DEVELOPMENT APPLICATION ASSESSMENT REPORT

Application Number:	DA2023/1532
----------------------------	-------------

Responsible Officer:	Adam Croft
Land to be developed (Address):	Lot 2 DP 412086, 15 Ocean Road PALM BEACH NSW 2108
Proposed Development:	Demolition works and construction of a dwelling house including swimming pool
Zoning:	C4 Environmental Living
Development Permissible:	Yes
Existing Use Rights:	No
Consent Authority:	Northern Beaches Council
Delegation Level:	NBLPP
Land and Environment Court Action:	No
Owner:	Kalloghlian Investments Pty Ltd
Applicant:	Barry Babikian

Figure 1. Applicant's illustration of the proposed building height breach as measured from the natural ground levels (subject dwelling is in the middle)

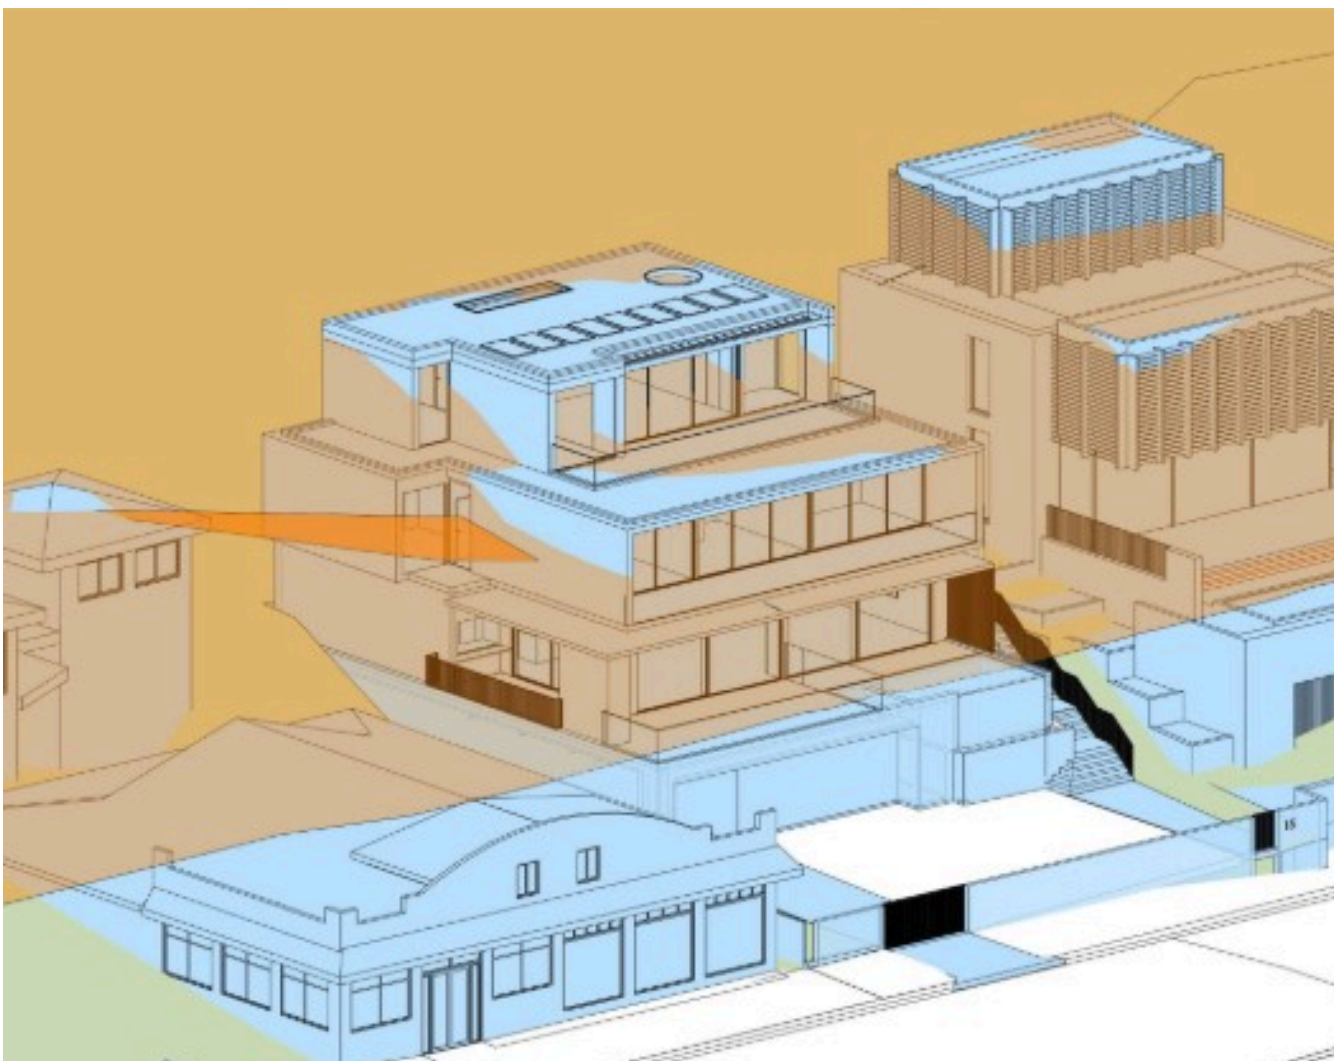
The above height plane diagram is not certified and indicates the proposed building height variation as measured from the assumed natural ground levels of the site. On that basis, the diagram is included for illustrative purposes only. Figures 2 and 3 included below indicate Council's calculation of the proposed building height breach at Sections 01 and 04, based on existing ground levels taken from the survey plan. It is noted that the assumed natural ground levels indicated on the architectural plans appear to be inaccurate in various areas, notably within the southern side setback area on Section 04, where the natural ground levels shown are well below the level of the existing retaining wall surveyed at RL7.78. These inaccuracies do not affect the calculation of the maximum building height as measured from the existing ground levels, but do bring into question the veracity of the assumed natural ground levels which are relied upon in the Clause 4.6 variation request.

Figure 2. Section 01 extract with building height variation shaded red (existing ground levels) and outlined in red (Applicant's assumed natural ground levels)

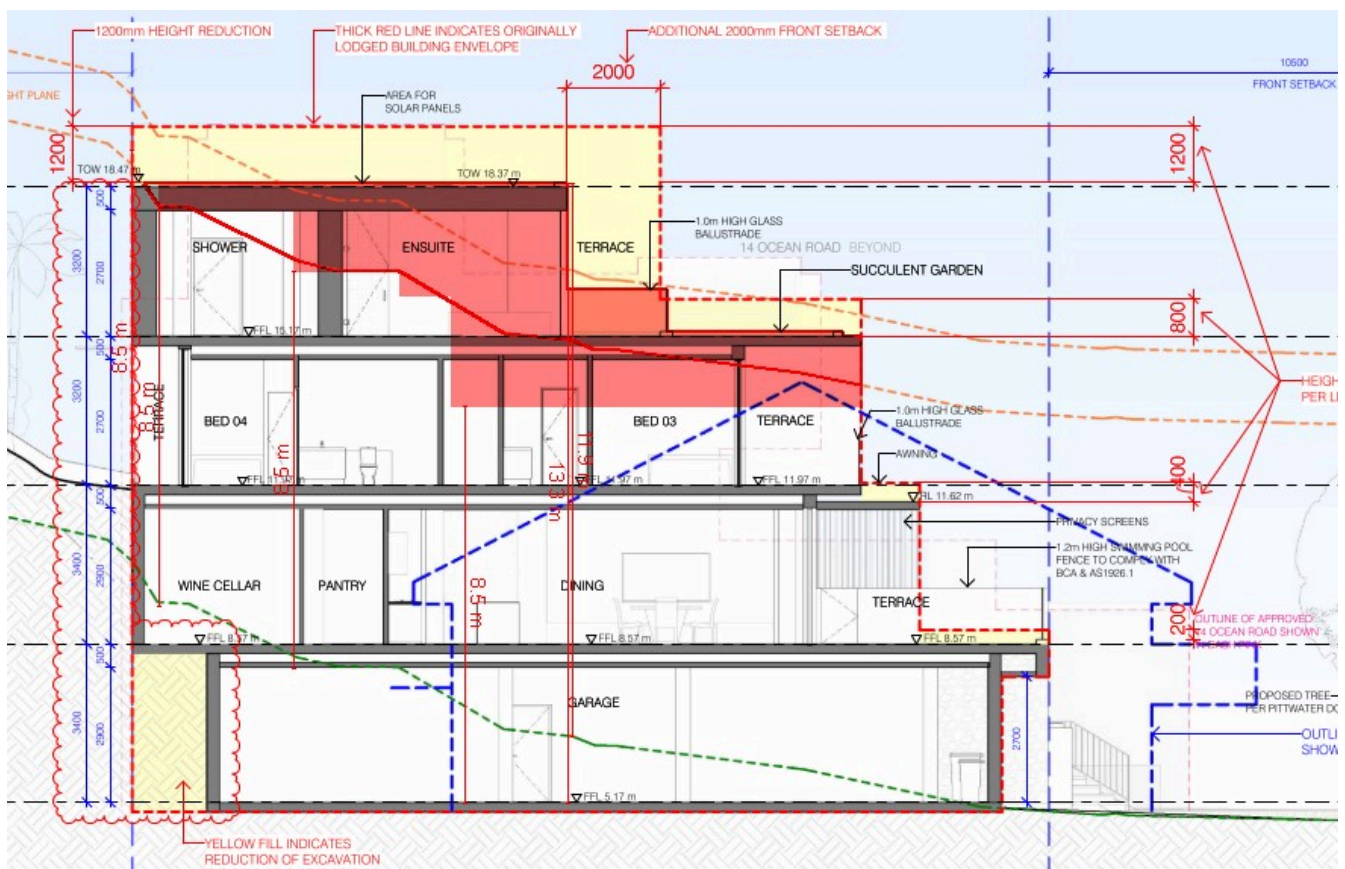
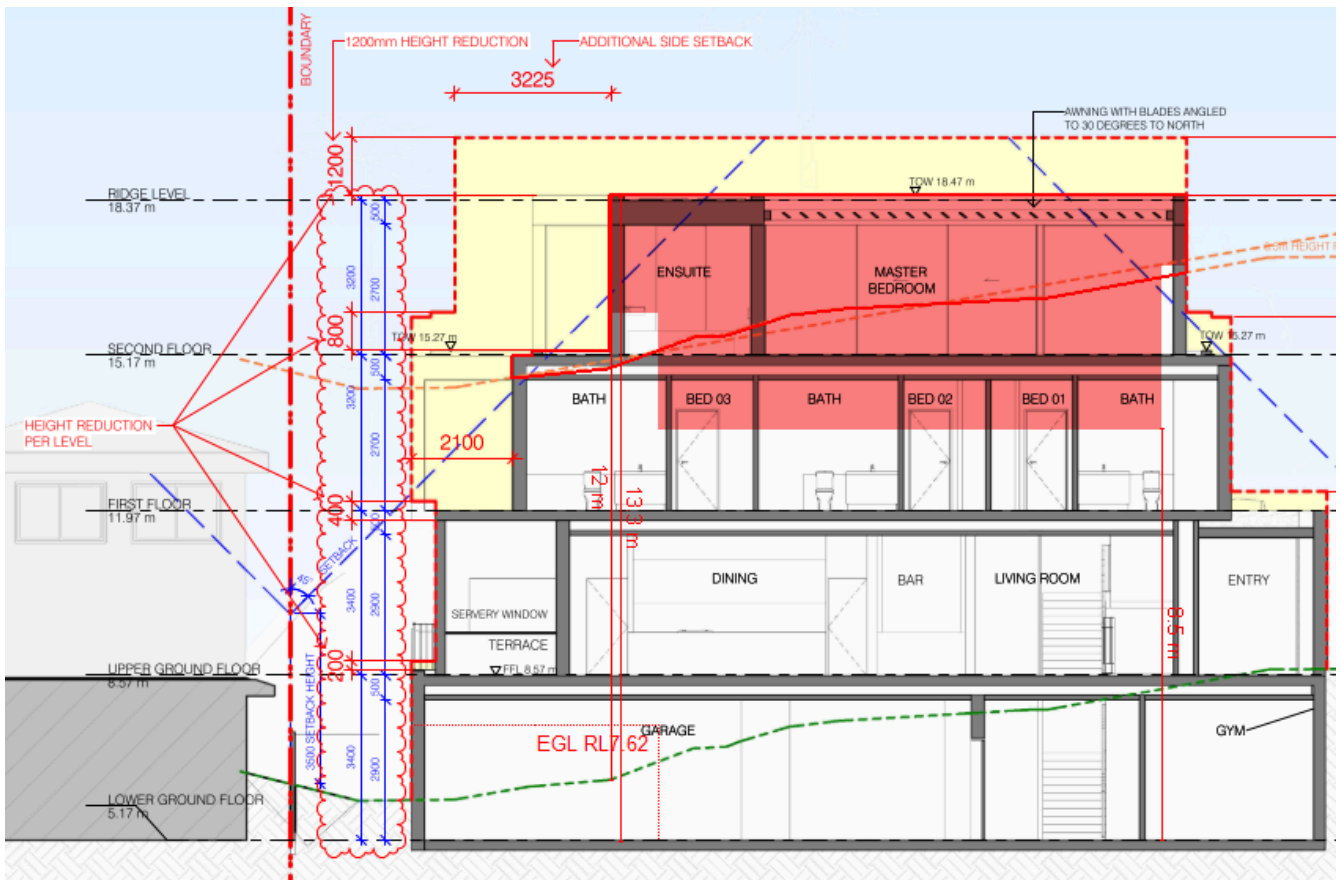
It is acknowledged that the site has been subject to prior excavation and that this does contribute in part to the extent of the height variation sought. However, as demonstrated in Figures 2 and 3 above, a large proportion of the dwelling still significantly exceeds 8.5m, as measured from the assumed natural levels of the site, up to a maximum height of 11.9m. Rather than the previous excavation of the site, the primary factor contributing to the building height variation is the desired four-storey built form. Therefore, while properly identified as an environmental planning ground, the prior excavation of the site is not a sufficient justification for the variation sought.

Figure 5. Overlay of the existing and proposed dwellings at Section 01, with the additional view corridor created at the front of the site shaded green

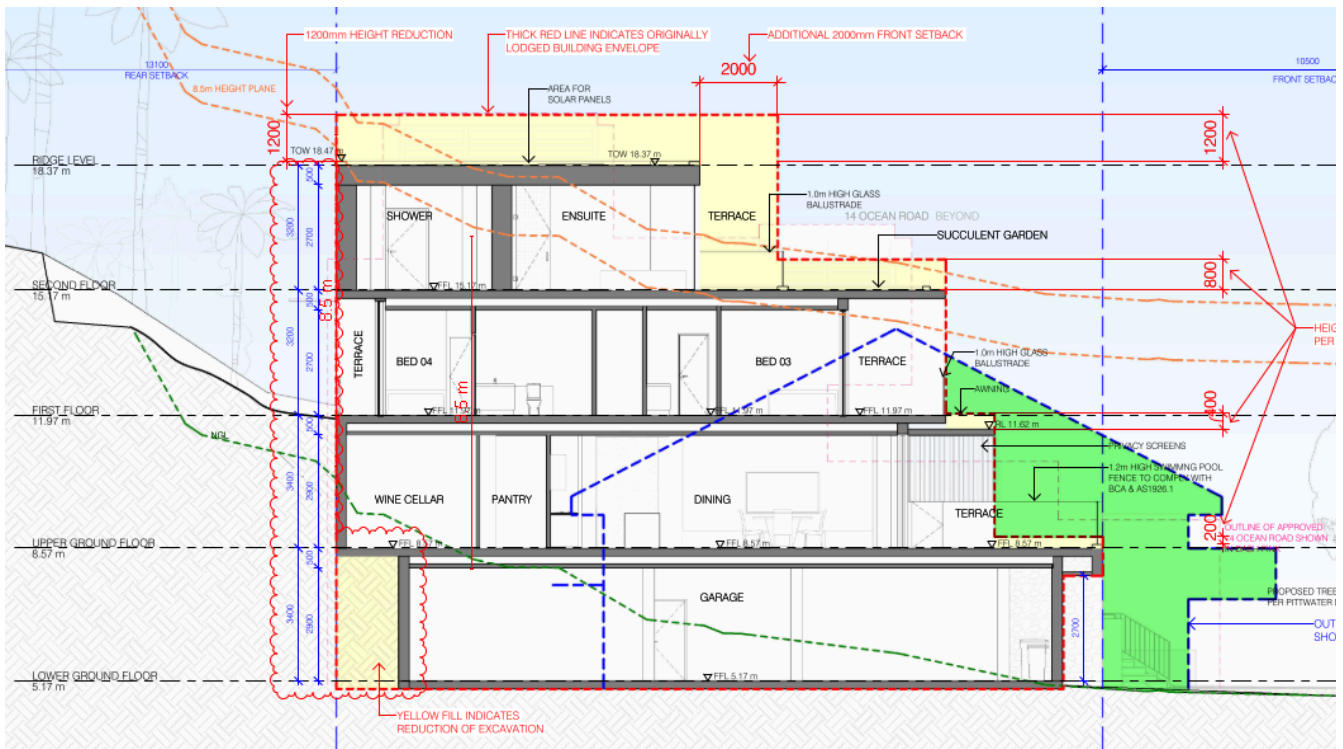
Based on the inspection of Nos. 14 and 16 Ocean Road and an analysis of the proposed plans, it is expected that the proposed development would not adversely impact the views presently available from the dwellings and rear private open space areas of those properties, as shown in Photos 5 and 6 below. It is expected that the available views from Nos. 14 and 16 would be improved through the front portion of the subject site based on the increased front setbacks proposed relative to the existing dwelling, as demonstrated in Figure 5 below. Easterly views from the front of the dwellings would also be unaffected.

Figure 6. Northern elevation building envelope breaches

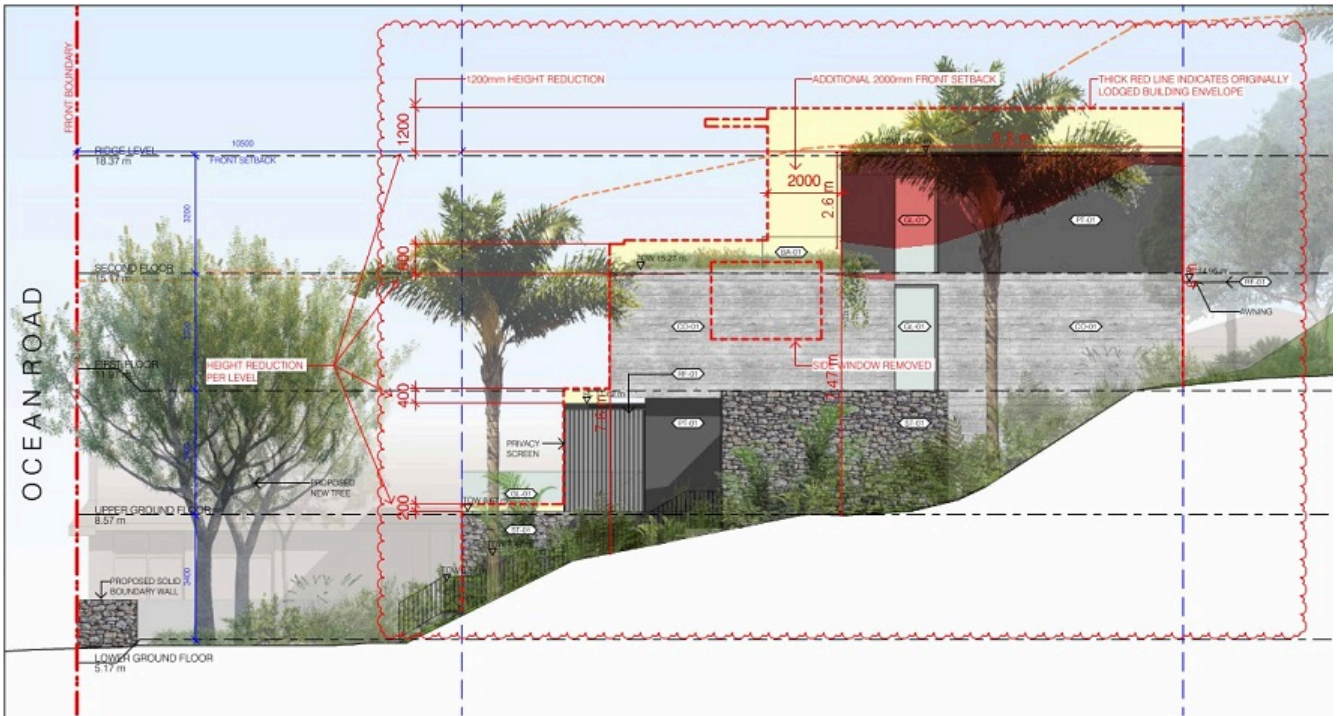
The proposed additions result in several breaches the building envelope control shown shaded red on the below plan extracts.

The number and extent of envelope encroachments are not reflective of a design that responds to the topography of the site, with substantial variations to the control on the first and second floors of the dwelling. The extent of excavation proposed, which is not evident on the above drawing, also fails to respond to the topography of the site.
